1 February 2021
20210201 - Gardens of Peace - Response to Written Questions
(WQ1)

Gardens of Peace Muslim Cemetery (Plot 1/8) – Response to Written questions (WQ1) in respect of Deadline 2 – M25 Junction 28 Improvement Scheme

GROUND SURFACING-Area 2

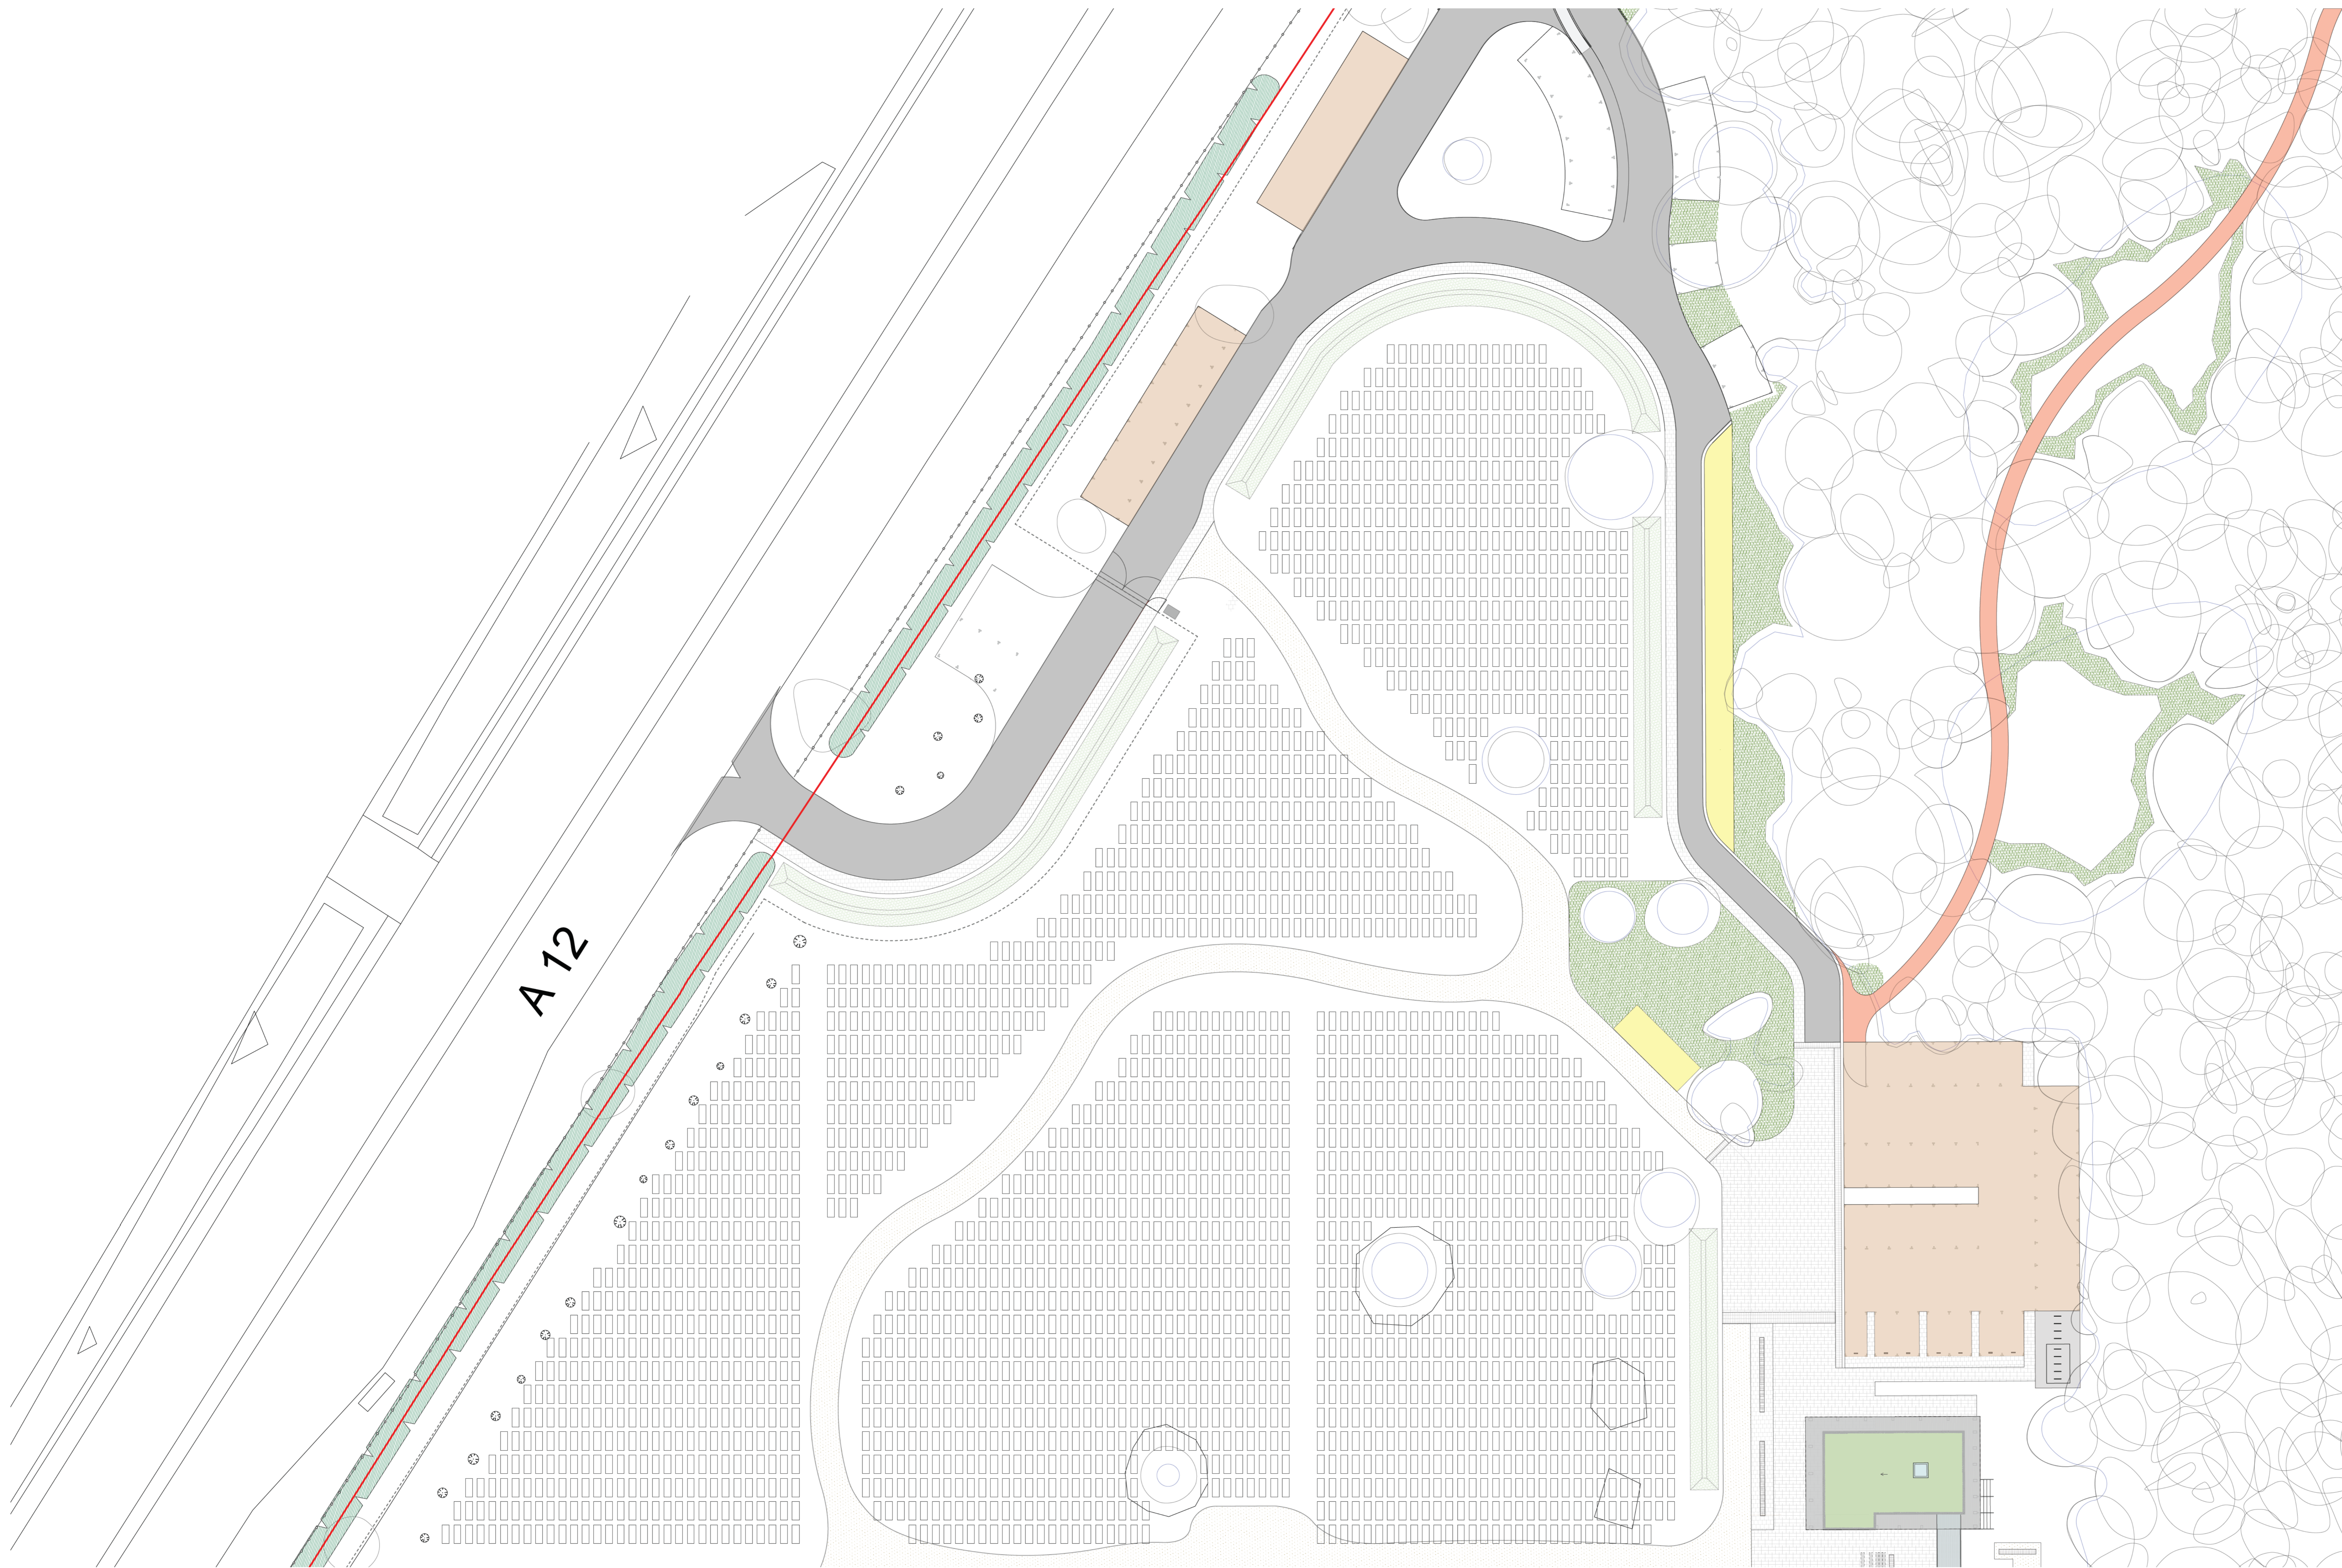
The DCO application identified Plot 1/8, as an area that will be subject to acquisition of permanent rights, thus, and as referred to later in this answer, it is assumed all land will be sterilised from its attended use, being internal road, underground services and 512 burial plots. We attach the development plan for the cemetery (see Appendix 1) and when overlaid with the Plot 1/8 boundary (Appendix 2), the severity of the gas main diversion works (Work No. 29) on Gardens of Peace development becomes evident.

By the time the gas main installation works commence, the cemetery development would have been completed and the cemetery will be operational. In terms of what this means for Plot 1/8, and as identified within Appendix 1 and 2, Plot 1/8 will be subject to an internal road, a 'service entrance' directly off Colchester Road (A12), a soil storage area, further utilities, part of an overflow car park and land prepared for 512 burial plots. In addition, during 2020, Gardens of Peace commenced some initial ground works, which included installing underground services within the area falling within Plot 1/8.

The designated soil storage area, required for storing soil from burial plots (and which will subsequently be removed from Maylands on a regular basis), is to be located within the most easterly shaded red area in Appendix 1. As a result of the loss of internal road and service entrance, the soil storage area will need to be relocated to an alternative and accessible area within Maylands to allow for regular collection. However, as you will note from the Appendix 1, there is no such area available. As is evident within Appendix 2, the only solution to Gardens of Peace is to move the soil storage area to the area shaded grey to the west of the plan. However, with this comes a number of significant issues. These will be the temporary loss of burial plots, effect on biodiversity, compaction to soil prepared for burial plots and aesthetic appearance of the burial ground. Furthermore, access for heavy goods vehicles and plant machinery to and from the temporary soil storage site would impact on the roadways, which are only to be used by visitor traffic.

The overflow carpark, which partly falls within Plot 1/8, will need to be relocated to elsewhere on the site, which brings about the same issues highlighted above in relation to the soil storage area. As at commencement of the gas main installation works, the cemetery will be operational and thus the car park fundamental to daily congregations. Thus the car park will need to be relocated which, in light of the loss of an internal road, will create significant disruption to the traffic management and aesthetics of the site.

As the internal road falls within Plot 1/8, this will also become severed, thus losing access to the workshop / store. The need for access to the workshop / store is fundamental to the daily operations of Maylands and without it, prevents any form of business operating from Maylands. Whilst there have been discussions between Gardens of Peace and Cadent in relation to the requirement of a temporary road, any temporary proposals will provide yet further disruption for the cemetery development in terms of aesthetics, damage to and temporary loss of land prepared for burials, requirement for traffic management and effect on biodiversity.

Thus, the amendments Gardens of Peace seek are a significant reduction in the boundary of Plot 1/8 to immediately reduce the effects, both temporary and permanent, on the cemetery. Gardens of Peace also seek

an amendment to the route of the gas main, to reduce the area within Plot 1/8 subject to the gas main easement, thus reducing the permanent effects on the cemetery i.e. enabling Plot 1/8 to be fully reinstated to the same order as it was prior to the gas main installation works and as proposed within the development plan (see Appendix 1).

1 M25/J28 Cadent Detailed Design
1:500

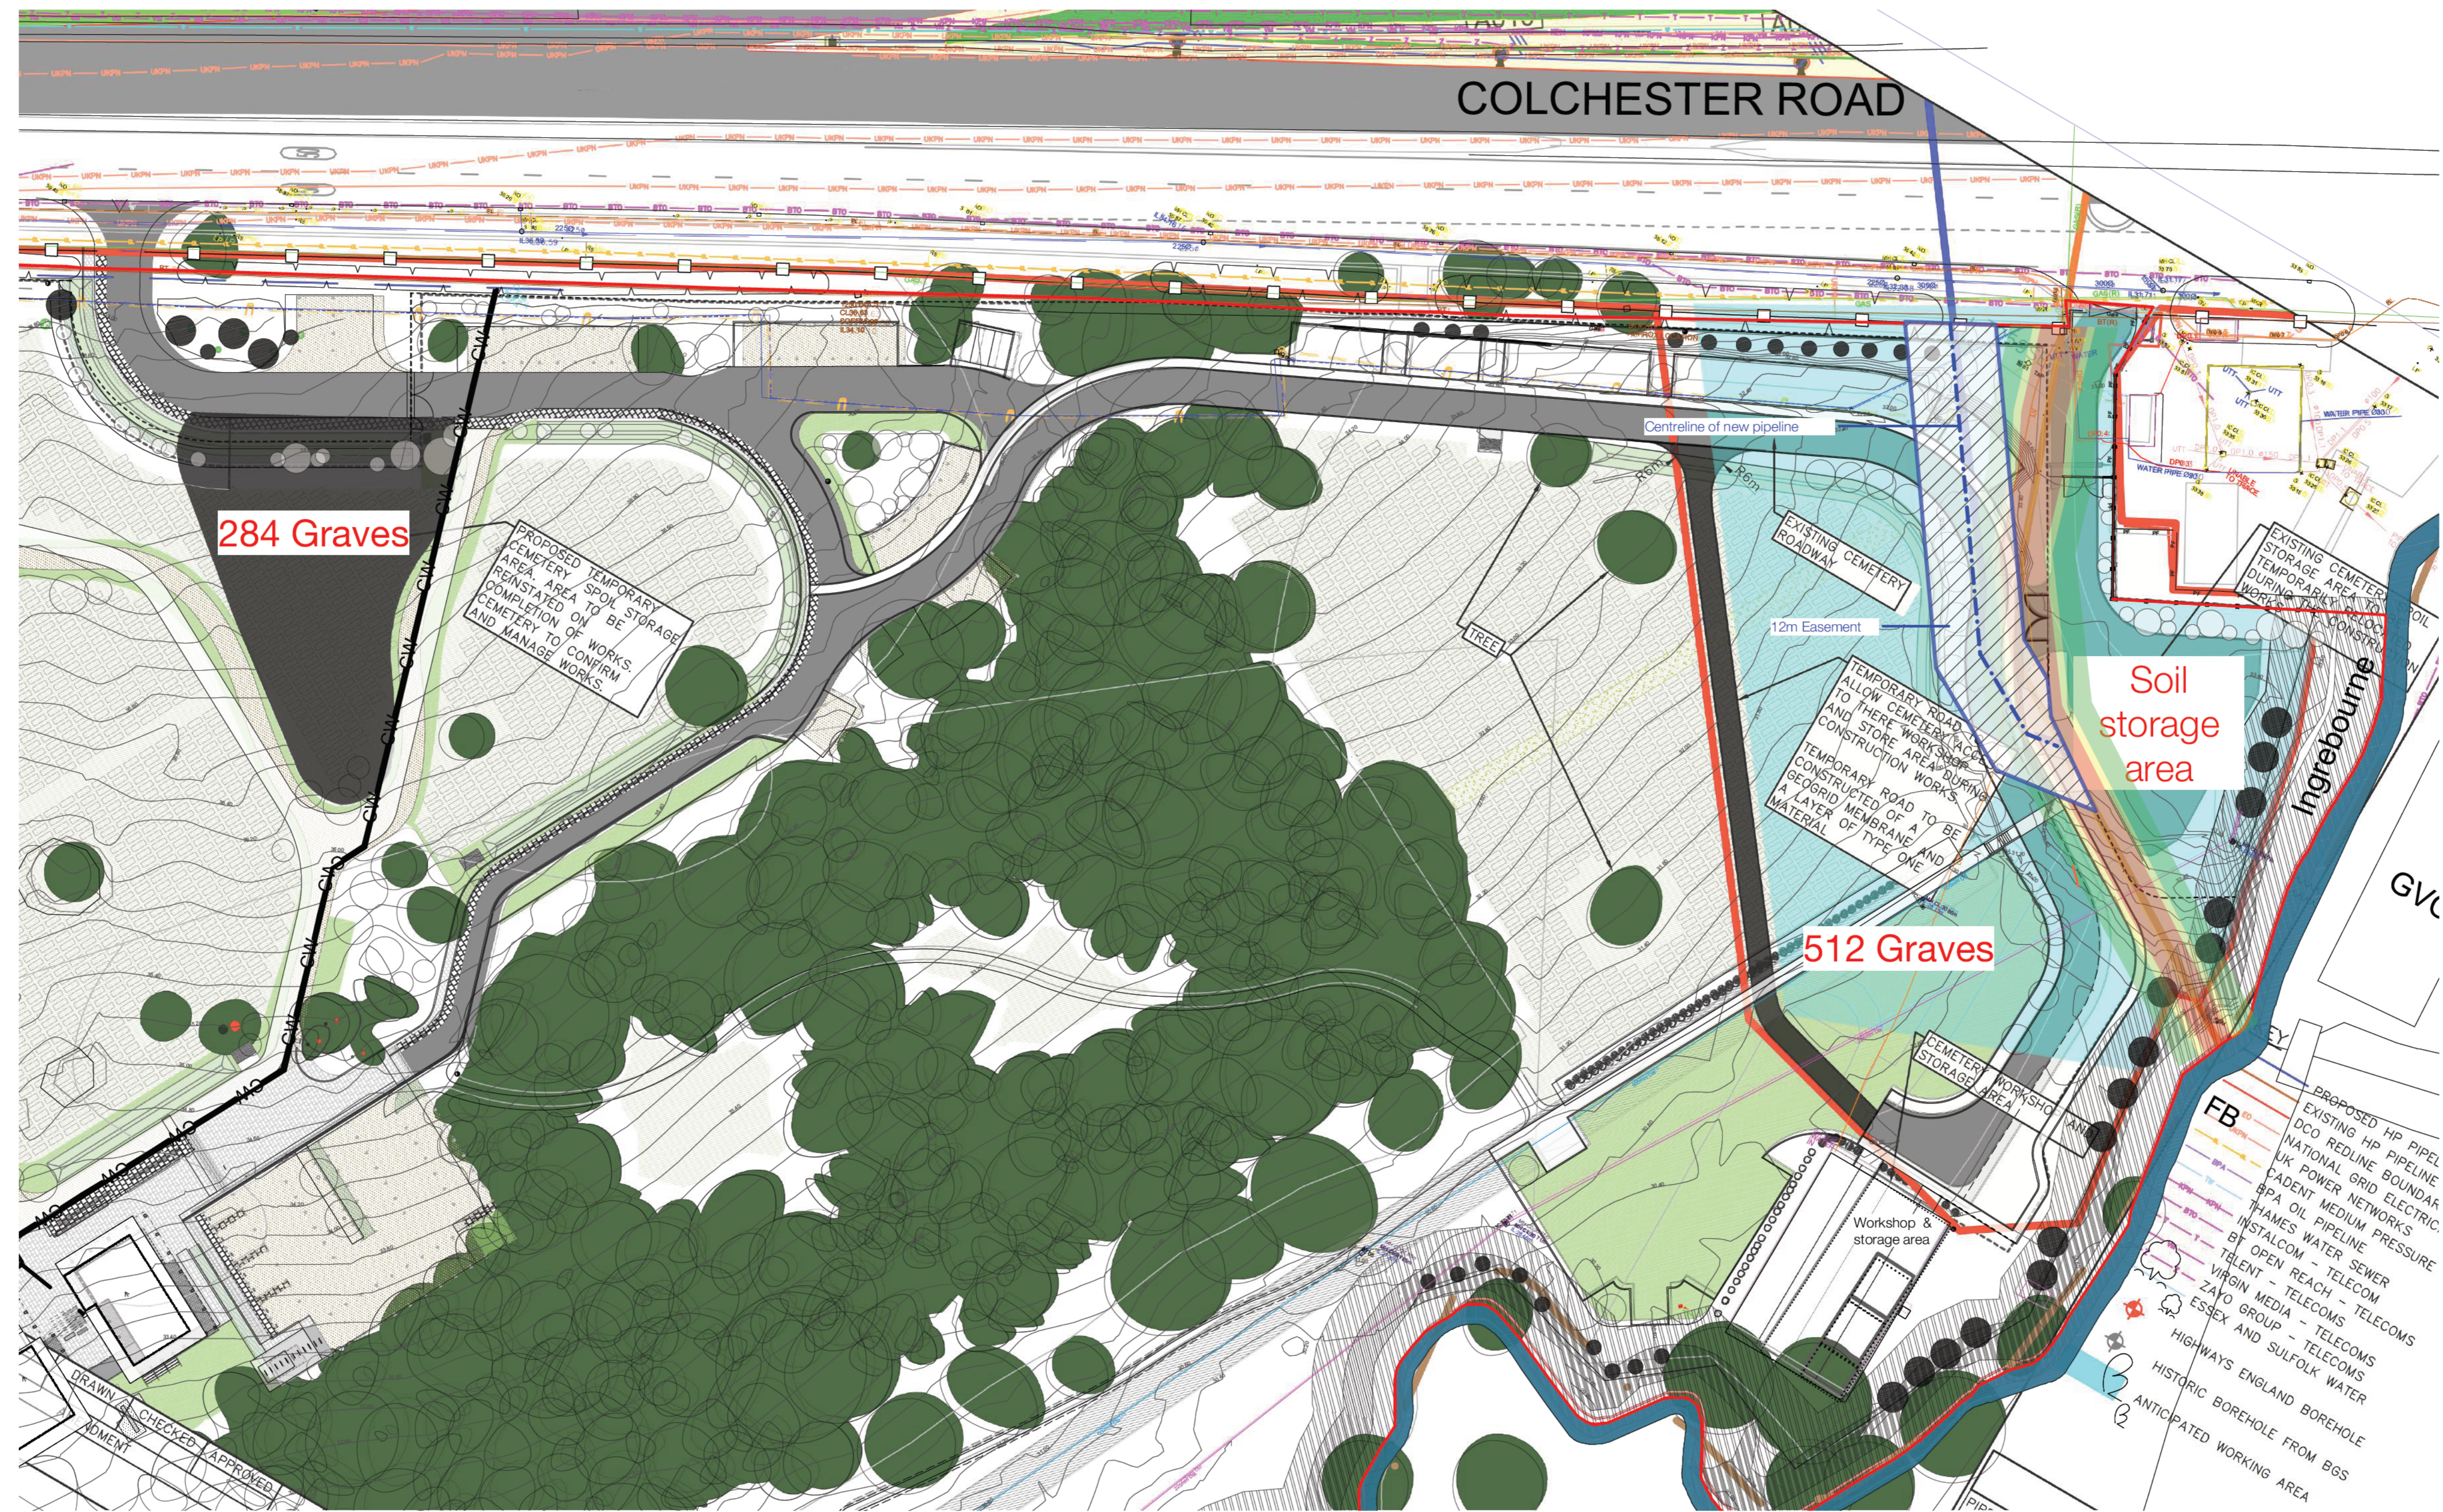
In light of that fact that the cemetery will be operational by the time the gas main works commence, utilities within Plot 1/8 will need to be relocated (see Appendix 3 – Cadent Detailed Design). These include the existing underground electrical, water and telecoms services to the workshop / store, which were installed in 2020 and

are now within the middle of the proposed gas main easement. Other services will include the drainage pipes under the internal road and associated manholes and chambers and underground lighting cables.

All services will have to be lifted and relocated to outside Plot 1/8 prior to the commencement of the gas main installation works to ensure the cemetery can continue to operate. Gardens of Peace is concerned with the effect of the temporary relocation of these services, which will need to be within land identified for burial plots, and accordingly the potential sterilisation of additional land in both the short and long term.
